Access Compliance Report

Public Rights-of-Way

Intersection ID: 43713	Main Street: BIESTERFIELD_DR	Cross Street: HUNT_GLENN_CT	Location: SW
ADA ID: 544B5EAC7478	Ramp Type: PerpDiag	Initial Pass/Fail: Fail	Overall Compliance: No
		Severity Score: 42.5

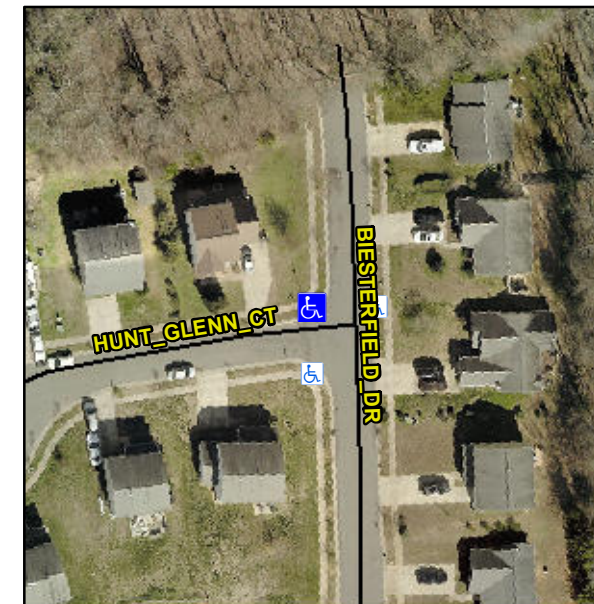
Not Found, R304.5.1, R304.5.3

Compliance	Description	Data	Compliance	Description	Data
N/A	Ramp Length (in)	47.0	Yes	Ramp Slope (%)	7.1
No	Ramp Width (in)	35.5	No	Ramp XSlope (%)	7.5
N/A	Flare Type LT	N/A	N/A	Flare Type RT	N/A
N/A	Flare Slope LT (%)	N/A	N/A	Flare Slope RT (%)	N/A
N/A	Flare Traversable LT?	N/A	N/A	Flare Traversable RT?	N/A
N/A	Landing Length (in)	N/A	N/A	DWS Provided?	N/A
N/A	Landing Width (in)	N/A	N/A	DWS Contrast?	N/A
N/A	Landing Slope (%)	N/A	N/A	DWS Length (in)	N/A
N/A	Landing X Slope (%)	N/A	N/A	DWS Full Width?	N/A
N/A	Landing Curb? (Y/N)	N/A	N/A	DWS Offset (in)	N/A
N/A	Shared Landing?	N/A			
N/A	Gutter Ponding?	N/A	N/A	Gutter Slope (%)	N/A
N/A	Gutter Lip Ht (in)	N/A	N/A	Gutter X Slope (%)	N/A
N/A	Painted X Walk1?	No	N/A	Painted X Walk2?	No
	X Walk 1 Direction	To SW		X Walk 2 Direction	To SE
N/A	X Walk 1 Width (in)	N/A	N/A	X Walk 2 Width (in)	N/A
	X Walk 1 Slope (%)	2.5		X Walk 2 Slope (%)	3.3
	X Walk 1 X Slope (%)	4.1		X Walk 2 X Slope (%)	4.7

Remove & Replace Curb Ramp With Two New Directional Ramps or Equivalent.
